Access Compliance Report

Public Rights-of-Way

(Curb Ramps)

Intersection ID: 23104	Main Street: PENSFORD_LN	Cross Street: LYNBRIDGE_DR	Location: NE
ADA ID: 87E62A2C9FBC	Ramp Type: Perp	Initial Pass/Fail: Fail	Overall Compliance: No
Severity Score: 33.75			
Codes/Mitigation Info/Possible Solution		Field Measurements/Component Compliance

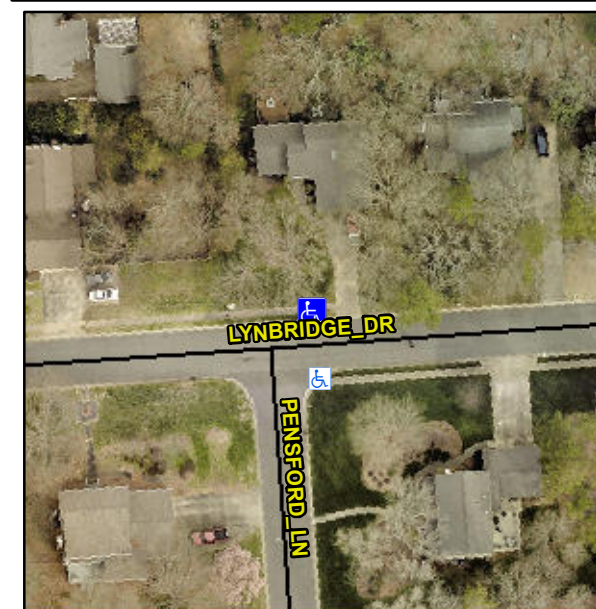
Not Found, R304.5.1, R304.5.3

Compliance	Description	Data	Compliance	Description	Data
N/A	Ramp Length (in)	34.0	Yes	Ramp Slope (%)	5.5
No	Ramp Width (in)	46.5	No	Ramp XSlope (%)	7.3
N/A	Flare Type LT	N/A	N/A	Flare Type RT	N/A
N/A	Flare Slope LT (%)	N/A	N/A	Flare Slope RT (%)	N/A
N/A	Flare Traversable LT?	N/A	N/A	Flare Traversable RT?	N/A
N/A	Landing Length (in)	N/A	N/A	DWS Provided?	N/A
N/A	Landing Width (in)	N/A	N/A	DWS Contrast?	N/A
N/A	Landing Slope (%)	N/A	N/A	DWS Length (in)	N/A
N/A	Landing X Slope (%)	N/A	N/A	DWS Full Width?	N/A
N/A	Landing Curb? (Y/N)	N/A	N/A	DWS Offset (in)	N/A
N/A	Shared Landing?	N/A			
N/A	Gutter Ponding?	N/A	N/A	Gutter Slope (%)	N/A
N/A	Gutter Lip Ht (in)	N/A	N/A	Gutter X Slope (%)	N/A
N/A	Painted X Walk1?	No	N/A	Painted X Walk2?	N/A
	X Walk 1 Direction	To S		X Walk 2 Direction	N/A
N/A	X Walk 1 Width (in)	N/A	N/A	X Walk 2 Width (in)	N/A
	X Walk 1 Slope (%)	4.9		X Walk 2 Slope (%)	N/A
	X Walk 1 X Slope (%)	6.5		X Walk 2 X Slope (%)	N/A

N/A	Ramp inside XWalk1?	N/A	N/A	Ramp inside XWalk2?	N/A
	Road Slope (%)	N/A	N/A	Clear Space?	N/A
	Road X Slope (%)	N/A	N/A	Clear Space to XWalk (in)	N/A
N/A	Any Obstructions?	N/A	N/A	Storm Grate/Utility Hazard?	N/A
	Obstruction Type			Storm Grate/Utility Type	
		N/A			N/A
			Yes	Surface Condition? (G/P)	Good

Remove & Replace Entire Ramp.
